# UNITED STATES PATENT AND TRADEMARK OFFICE

APPLICATION NO.	FILING DATE	FIRST NAMED INVENTOR	ATTORNEY DOCKET NO.	CONFIRMATION NO.
10/725,704	12/02/2003	John C. Daynes	1023-126US02	4757

<b>Office Action Summary</b>	<b>Application No.</b> 10/725,704	<b>Applicant(s)</b> DAYNES ET AL.	
	<b>Examiner</b> Joseph S. Machuga	<b>Art Unit</b> 3762

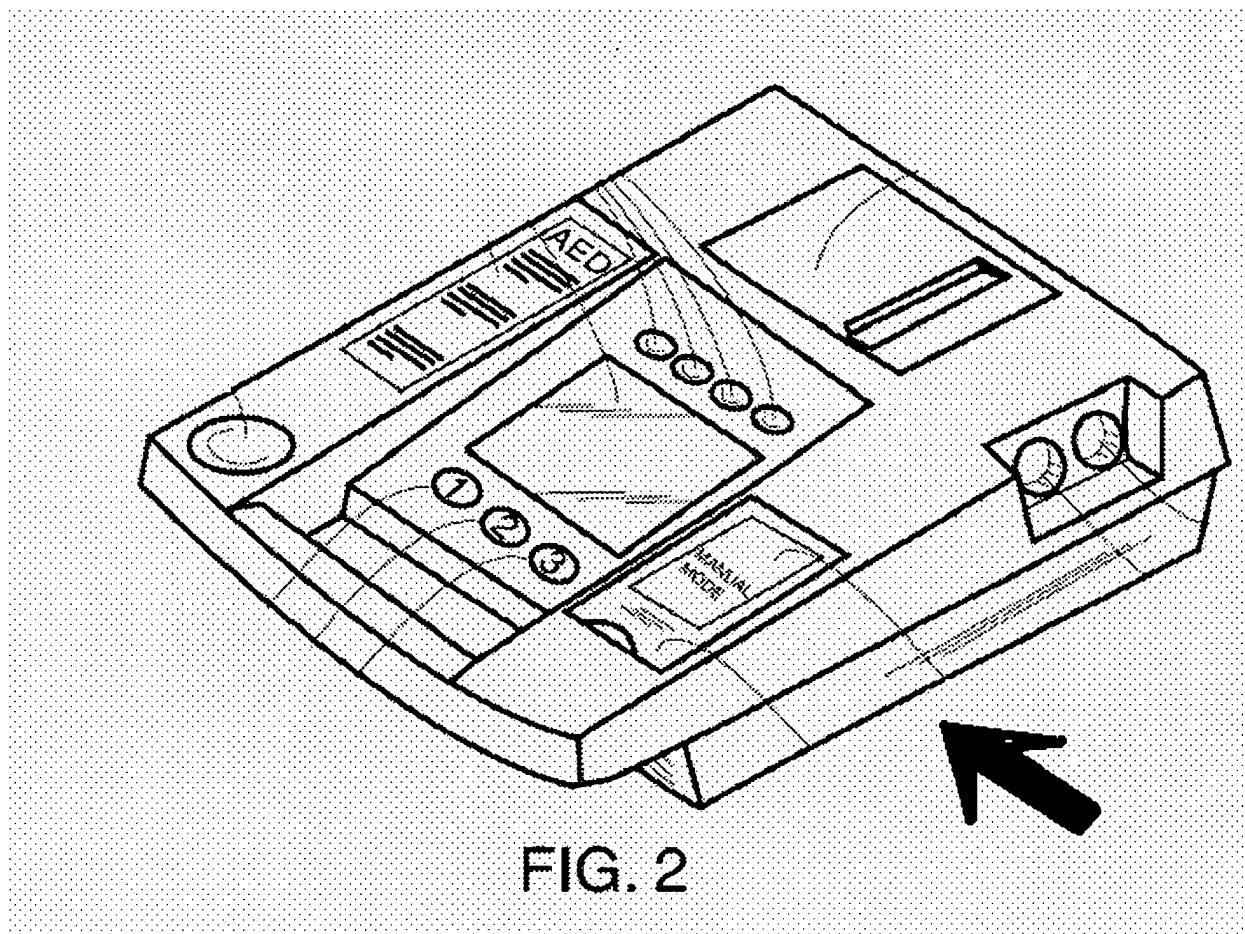
Regarding claim 17 viewing the device from the right side in Fig 2 (note picture on the following page) the AED buttons would be behind the door as recited in the claim.
